Overview: Production error in version 1.0 harnesses; The immobilizer wire (orange/black) is in pin position #4 instead of pin position #5. Although an effort to correct the issue was made, some quantity of harnesses did get shipped before the issue was spotted. We are advising to inspect the harness BLADE connector before attempting to install harness or program the module. This issue is not known to affect the version 2 harnesses, which require no modification.

Overview: Early versions of the FTI-STP1 harness require modification for **automatic transmission (AT)** applications, some of the product was able to be modified before release, but a small quantity was released without modification.

MODIFICATION REQUIRED FOR A/T APPLICATIONS, ONLY WITH v 1.0 HARNESS

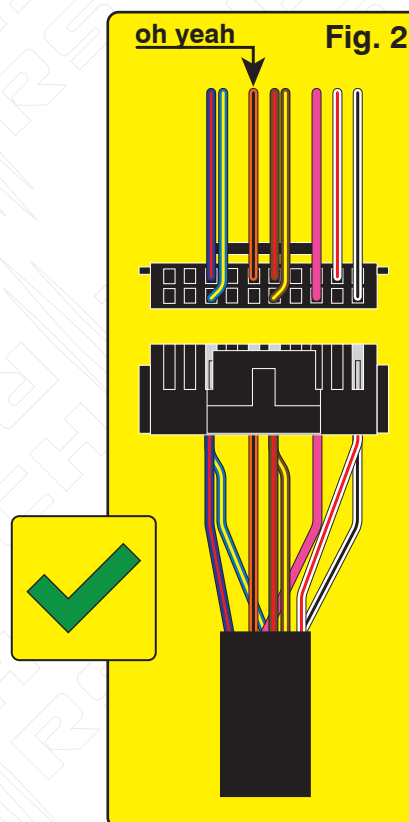
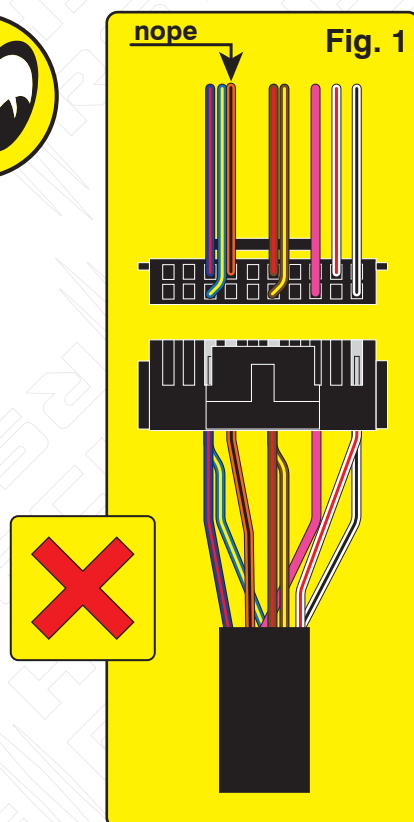
Issue: Module fails to program correctly to vehicle, does not allow the vehicle to be remote started.

Correction: Step 1.) Locate the orange/black wire and confirm whether it is positioned as illustrated in Fig. 1 or Fig. 2. If the wire is as illustrated in Fig.1, proceed with Step 2 through 5 and complete the repair procedure outlined, if the wire is as illustrated in Fig. 2, correction is not necessary, proceed with harness installation and module programming.

Step 2.) Using a pick, lightly depress the catch that secures the terminal in the housing then remove the wire and terminal from the housing.

Step 3.) Using a fine tip razor or utility knife, insert the blade beneath the terminal catch and raise it slightly, so that it can be reused to secure the terminal when reinserted into the BLADE connector housing.

Step 4.) Refer to Fig. 2 for correct position of the orange/black wire (next to brown/red) then reinsert the terminal, pressing lightly until the catch 'snaps' into place, securing the terminal in the connector housing.

Step 5.) The repair is complete, proceed with installation and programming.

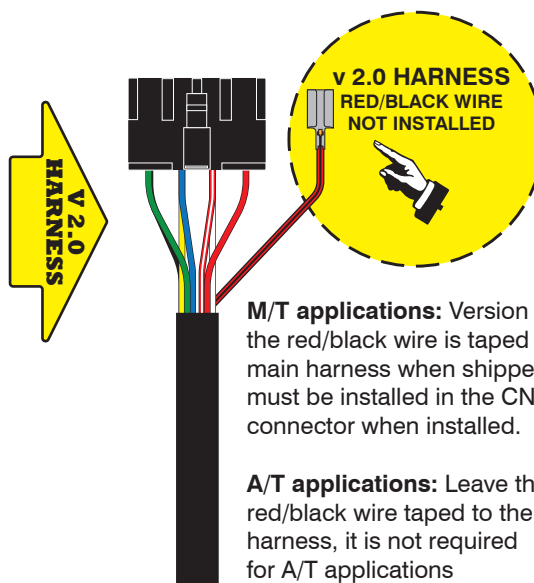
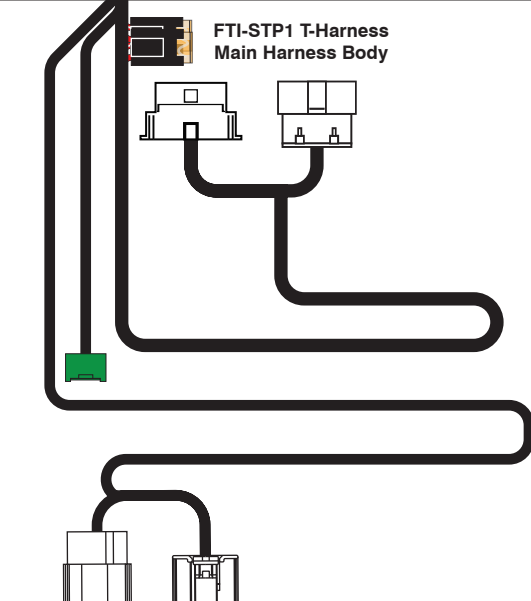
Issue: The FTI-STP1 T-harness has been designed to be compatible with A/T (automatic transmission) & M/T (manual transmission) applications, but due to an oversight in early production runs, the selection was defaulted to M/T mode.

Using a harness configured for an M/T application, in an A/T equipped vehicle, could result in vehicle module damage, it is advised that the harness be returned to A/T mode before installation in vehicles equipped with an automatic transmission.

Correction: Locate the **red/black** (+ Clutch) wire provided in the CN1 connector of the main harness assembly. Cut the **red/black** wire, either flush to the CN1 connector, or leaving enough wire exposed so that you can insulate and secure the ends of the wire that remain after cutting. Insulate each of the remaining ends of the **red/black** wire and secure to prevent any possibility of a short circuit. **If the red/black wire has already been disconnected, no further modification is required for A/T applications**
